Safety Recall: Electrical Noise May Cause Inadvertent Front Airbag Deployment

(Supersedes 13-038, *Safety Recall: Electrical Interference May Cause Inadvertent Front Airbag Deployment*, dated September 19, 2013; see REVISION SUMMARY)

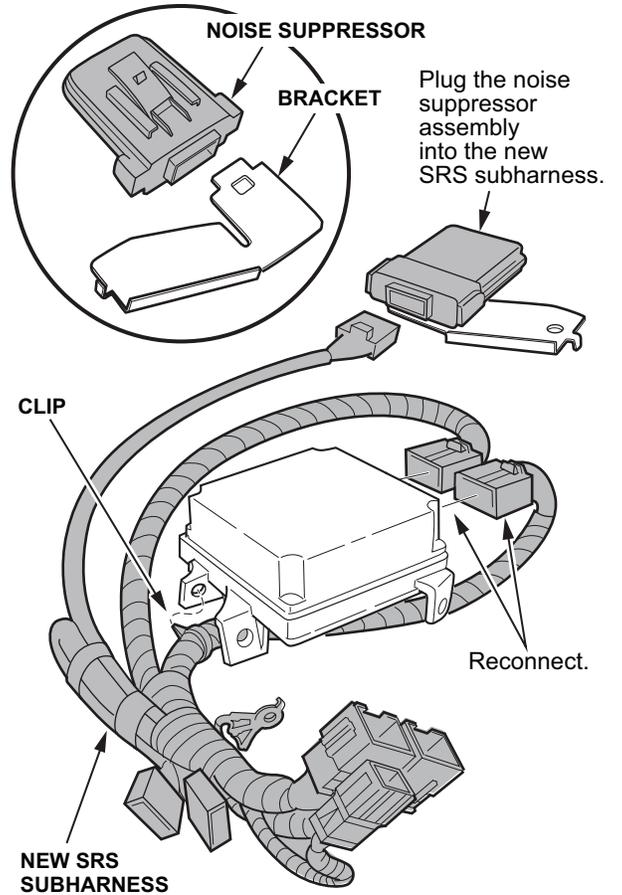
11. Install the new SRS subharness to the SRS unit:

- Install the noise suppressor onto the bracket.
- Connect the suppressor to the new SRS subharness.
- Connect the new subharness to the SRS unit and install the subharness clip to the underside of the unit.

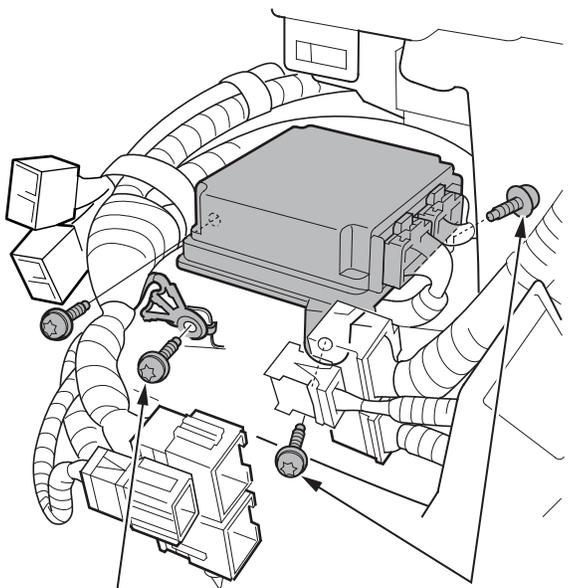
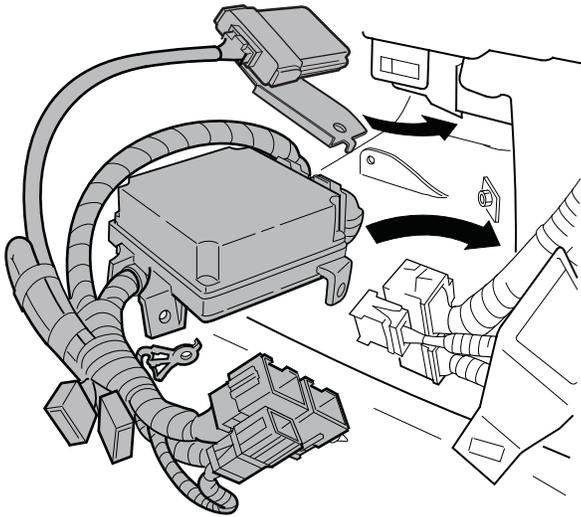
12. Reinstall the SRS unit into the vehicle:

- Make sure the SRS unit is squarely against its bracket and install the three Torx bolts. Torque them to **9.8 N•m (7.2 lb-ft)**.
- Install the fourth Torx bolt to secure the ground wire and torque it to **9.8 N•m (7.2 lb-ft)**.

**NEW SRS GROUND WIRE
TORX (T30) BOLT
9.8 N•m (7.2 lb-ft)**

**(3) NEW TORX
(T30) BOLTS
9.8 N•m (7.2 lb-ft)**

PASSENGER'S SIDE

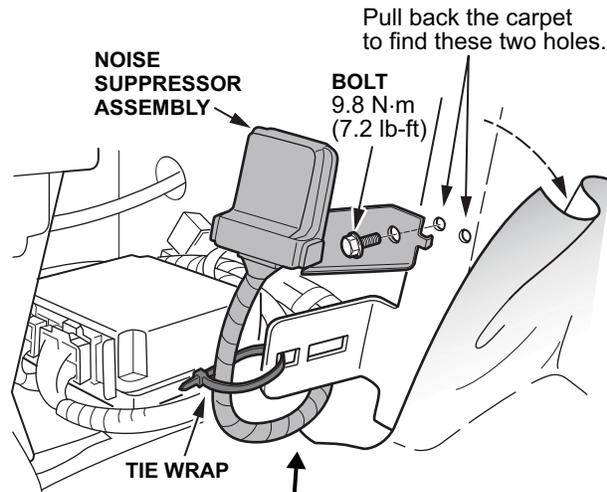
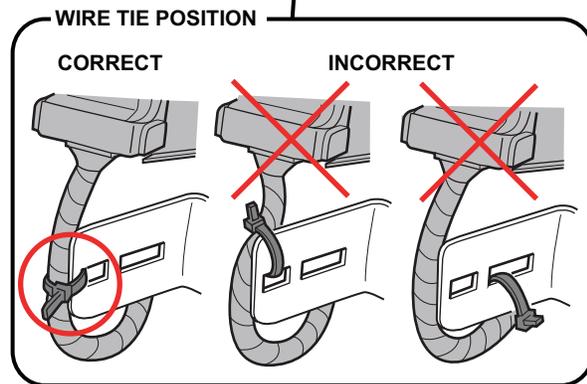
- Install the bracket with the noise suppressor in the threaded open hole on the passenger's side, and torque the bolt to **9.8 N•m (7.2 lb-ft)**.

Pull back the carpet to find these two holes.

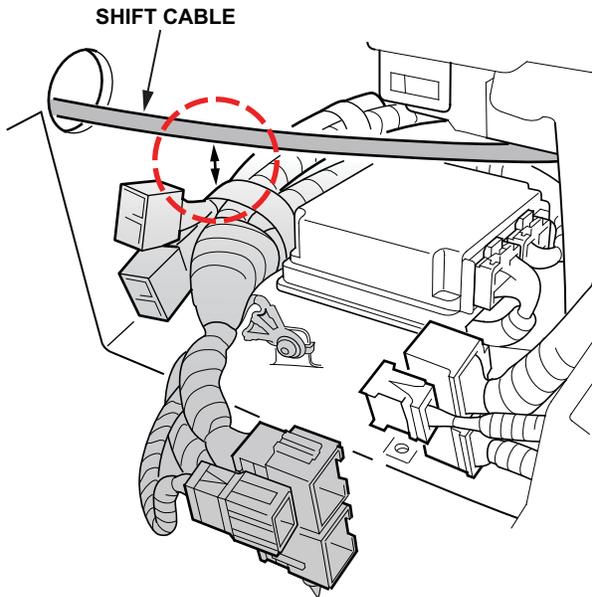
- Install a tie wrap as shown to hold the suppressor subharness in place.
